SERVICE BULLETIN

EOS engine

date of release	.Dec. 2018	issue 1, #1218_1_m
for engine type / applicability	engines EOS 150 (ICI)	
status	mandatory	optional

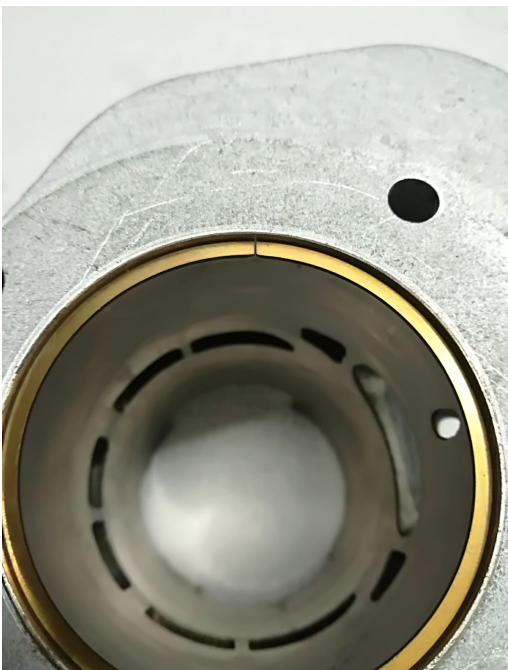
Dismount cylinder head and cylinder. Leave piston on crankshaft. Take off one upper piston ring and place into the cylinder as shown. Measure gap. Same with second piston ring. If in accordance to given measurement then place rings back to piston and reassemble engine.

If measurement of gap smaller than given measurement then correct gap with nail file.

Correct gap measurement; 0,22 - 0,30mm

Torque figure for the cylinder head nuts; 14NM

feeler gauge tool to correctly measure ring gap

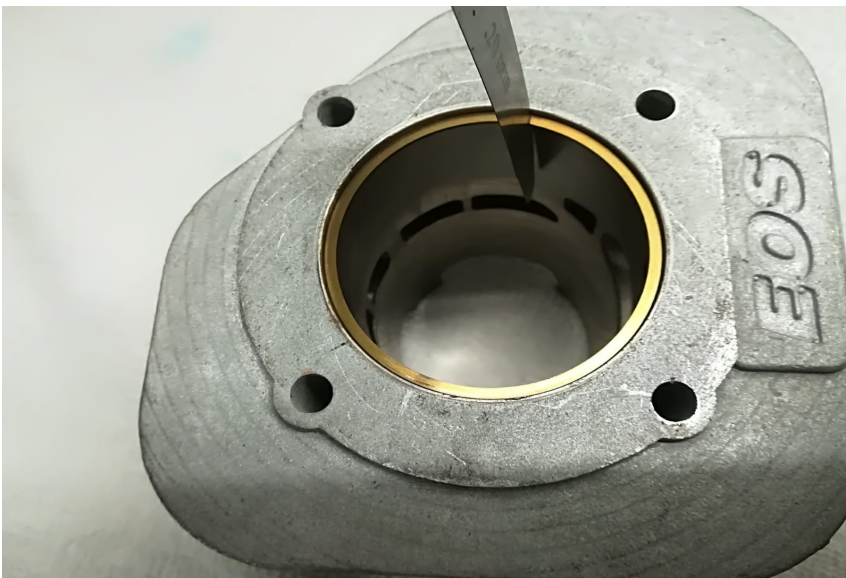
place ring into the bore of the cylinder as shown

measure gap

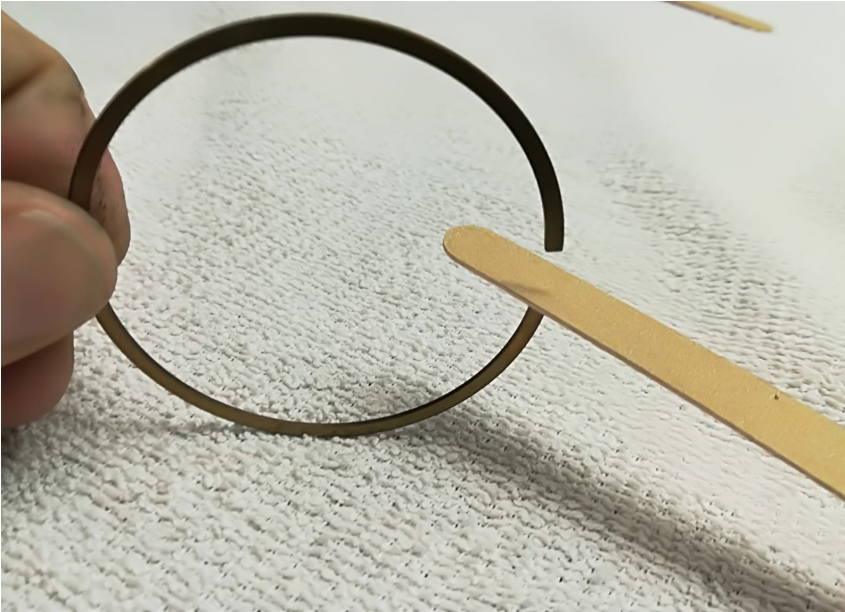
if necessary correct
gap with nail file
